WATER LICENCE INSPECTION FORM

| 2AM-MRY1325                                       |                                                | Environmental Superintendent                               |                                                  |
| June 22 – 24, 2018                                |                                                | Jonathan Mesher                                            |                                                  |

| On June22-24, 2018, a water licence inspection was conducted at the Mary River Project, Qikiqtani Region, Nunavut. Sites inspected included the Mary River Mine Site, the Tote Road and related infrastructure, and the Milne Port area.                                                                                                                                                                                         |                                              |                                                             |                                          |

Figure 4: East side of Waste Rock Stockpile.

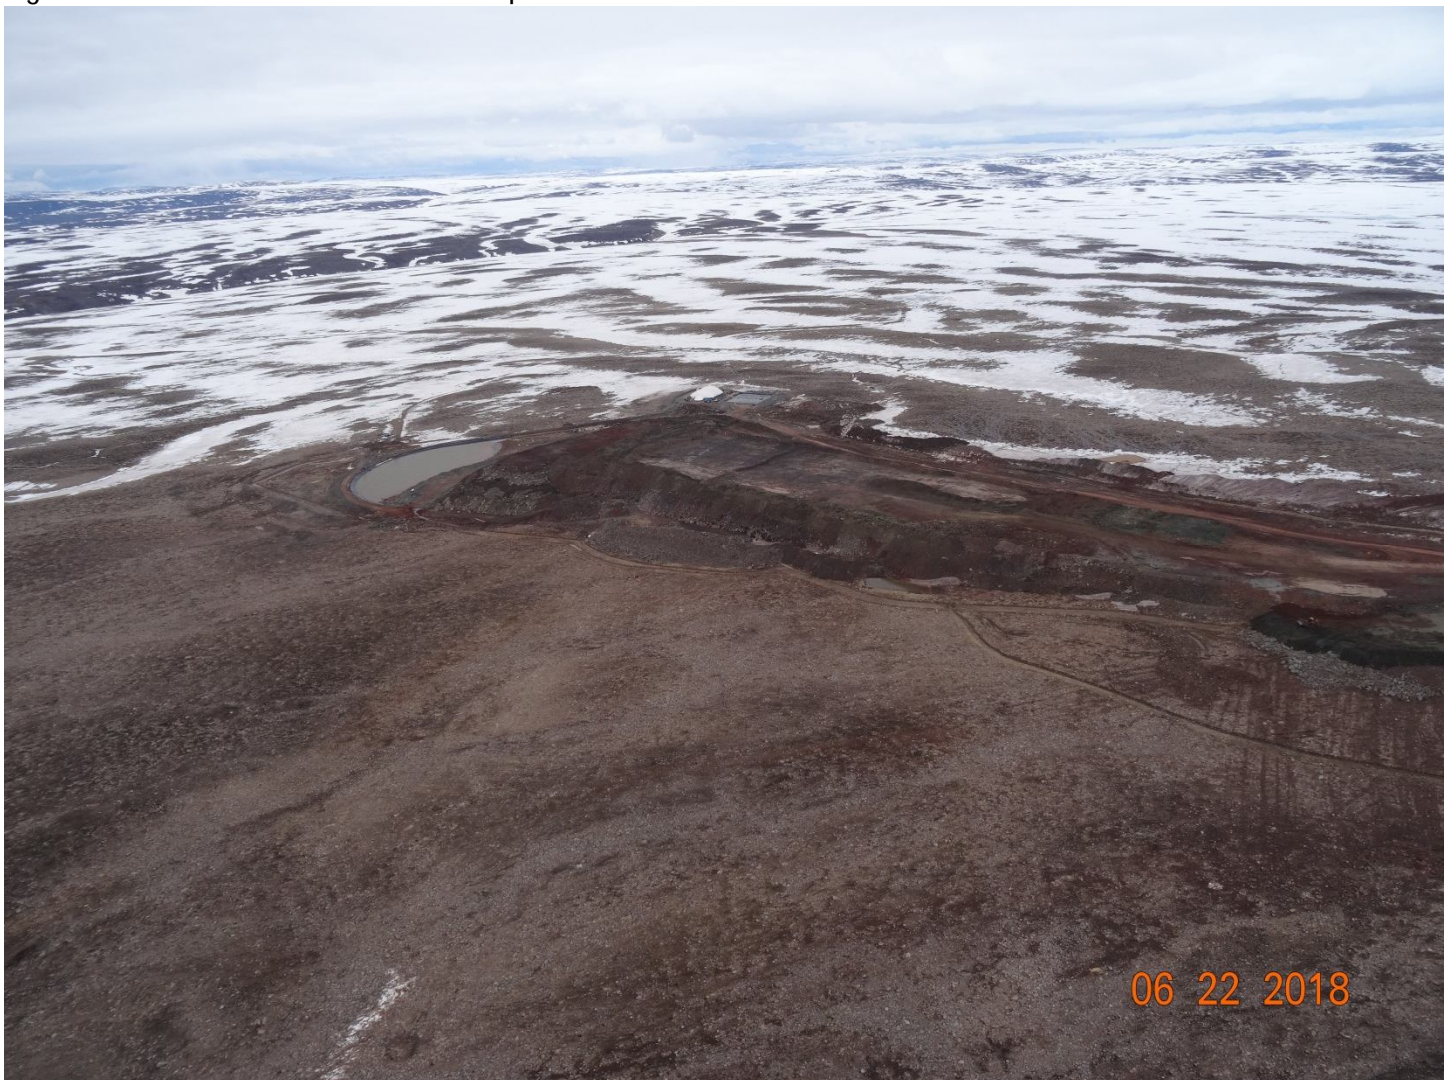
- c. See figures 4 and 5 for photos of the Waste Rock Stockpile.
